Evaluation of the report by Tokyo Electric Power Company regarding an alarm set off from a side ditch effluent radiation monitor at the Fukushima Daiichi Nuclear Power Station

Nuclear Regulation Authority
September 2, 2015

Figure 1. Layout drawing of drainage channels B and C, side ditch effluent radiation monitor and gates (excerpt from TEPCO's final report)

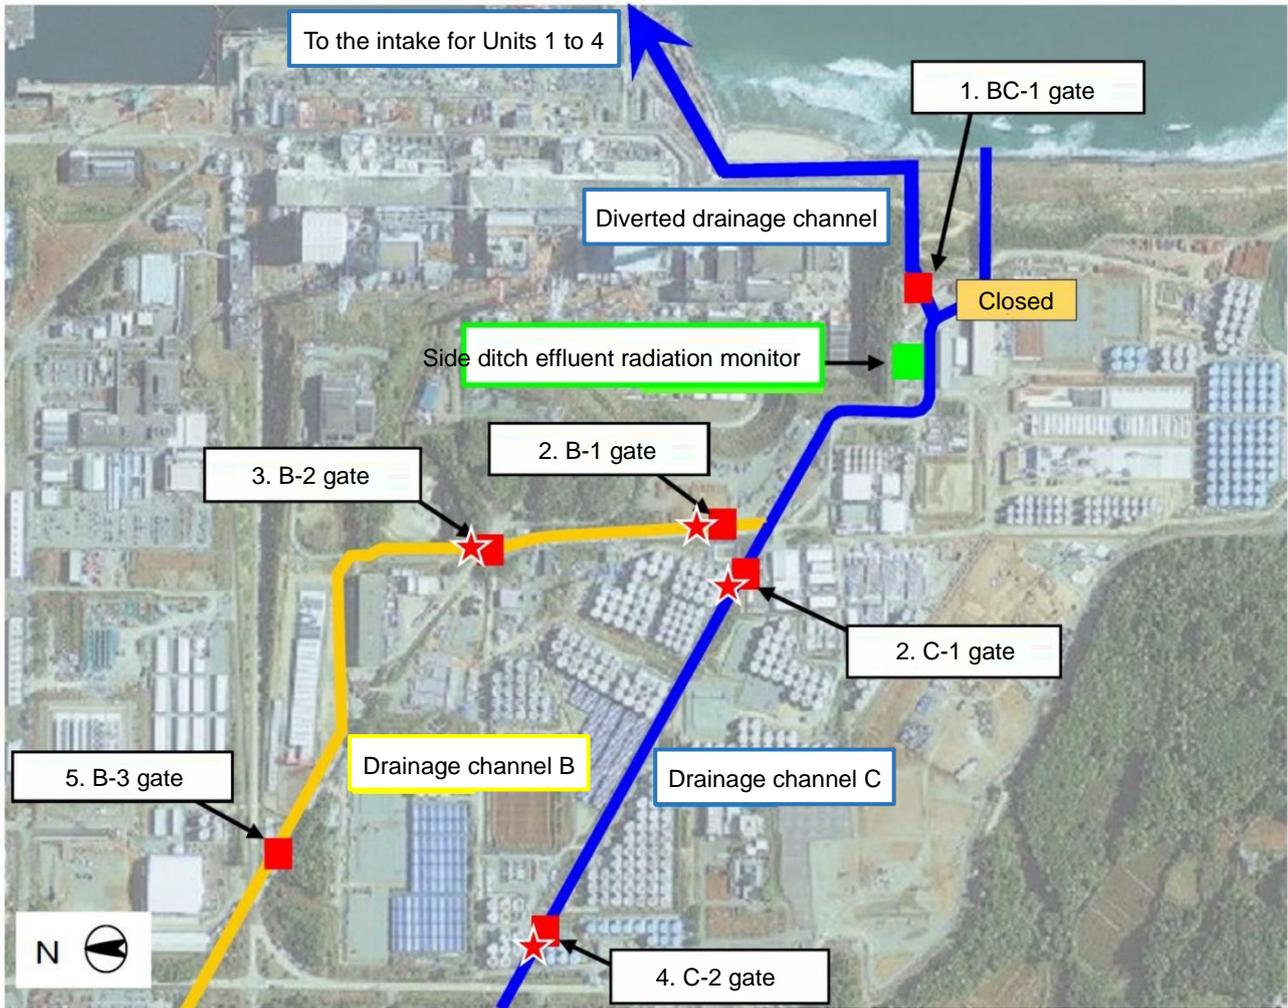
- Lighting equipment and pumps will be improved with gate closure and effluent collection work taken into account.
- To enable early detection of contamination, simplified radiation detectors are scheduled to be installed at four locations of drainage channels B and C (see Figure 1).

Figure 4. Results of analyzing radioactivity concentrations in the seawater in the port (excerpt from TEPCO's final report)

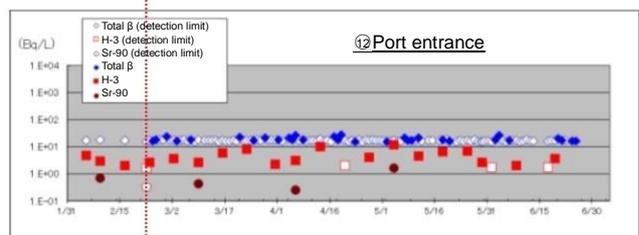
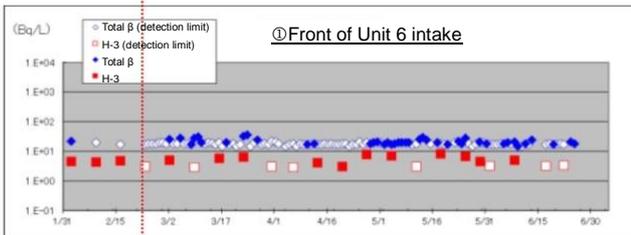
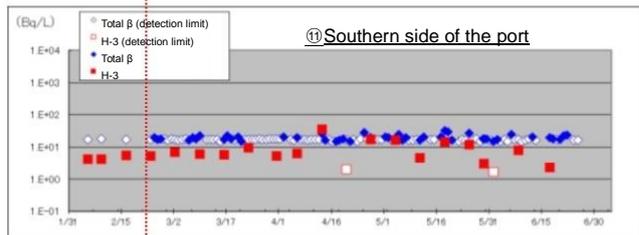
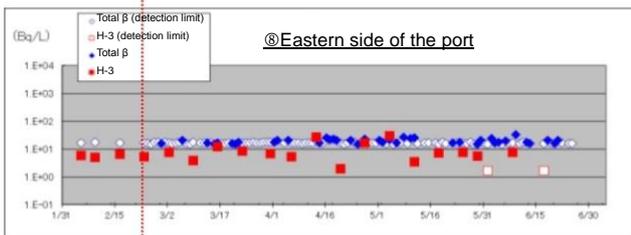
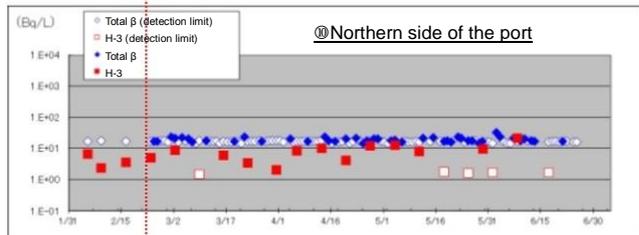
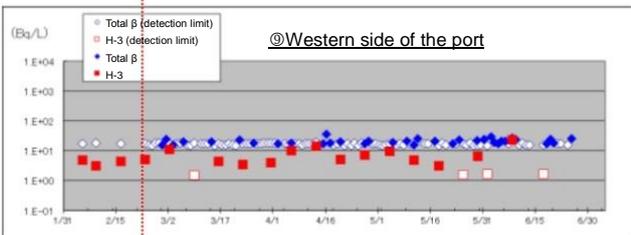
Because the results of monitoring the inside of the intake channels for Unit 1 to 4 and port showed that the radioactive concentrations of the total β nuclides inside them were within normal variation range and did not show significant fluctuation (see Figure 4), the NRA thinks that the contribution of the outflow of the high radioactive concentration effluent to the radioactive material concentration in the port was small (it was reported that the radiation level of the radioactive materials having flowed out into the port this time was estimated at about 1.7×10^8 Bq for ^{90}Sr , while the radiation level of ^{90}Sr that has been daily flowing into the port from the bank protection of the unclosed section of the seaside impermeable wall, estimated by the 33th Committee on Supervision and Evaluation of the Specified Nuclear Facilities on March 25, 2015, is 2.7×10^9 Bq/day).

Figure 5. Outline of the side ditch effluent radiation monitor (excerpt from final report by TEPCO)

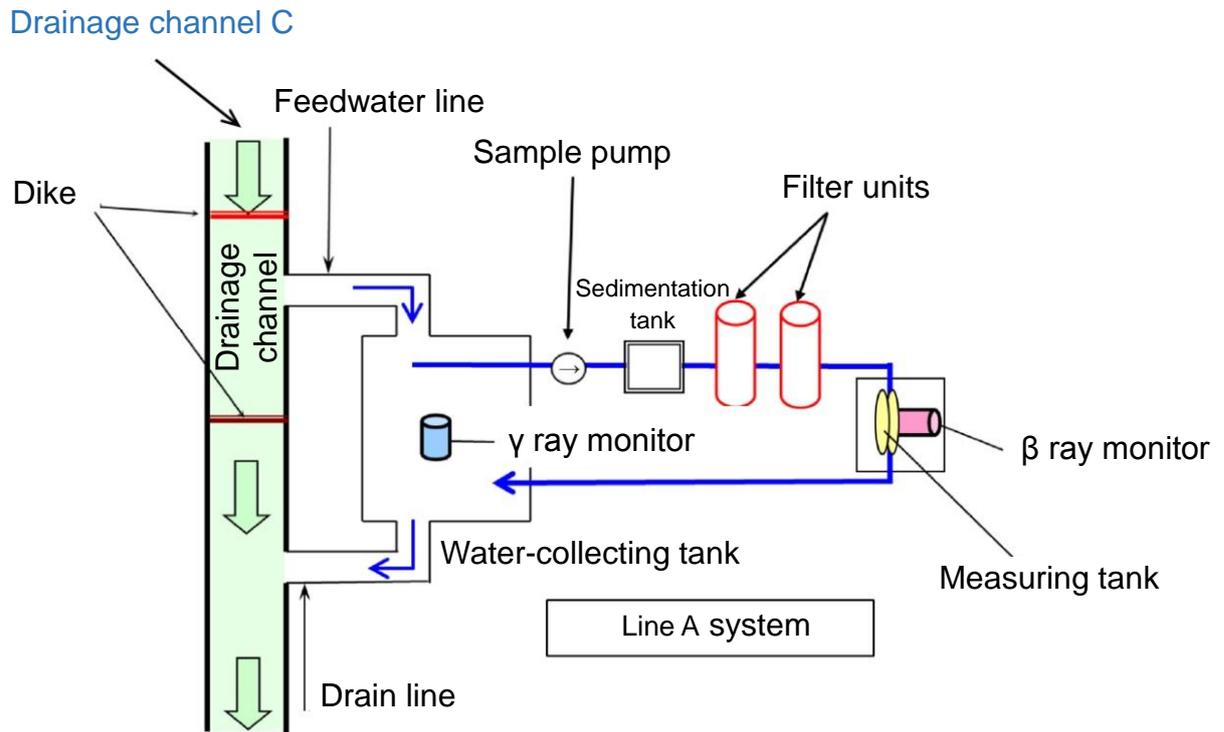
With regard to the TEPCO's estimate of the radiation level of the radioactive materials that outflowed into the port, namely 4×10^8 Bq for total β nuclides (about 1.7×10^8 Bq for $^{90}\text{Sr}^{*2}$), TEPCO has calculated the radiation level using the readings of the monitor and flow rates measured at drainage channel C while taking into account 30-minute delay caused by a sedimentation tank, etc. (see Figure 5). Therefore the NRA has concluded that this estimate is valid.
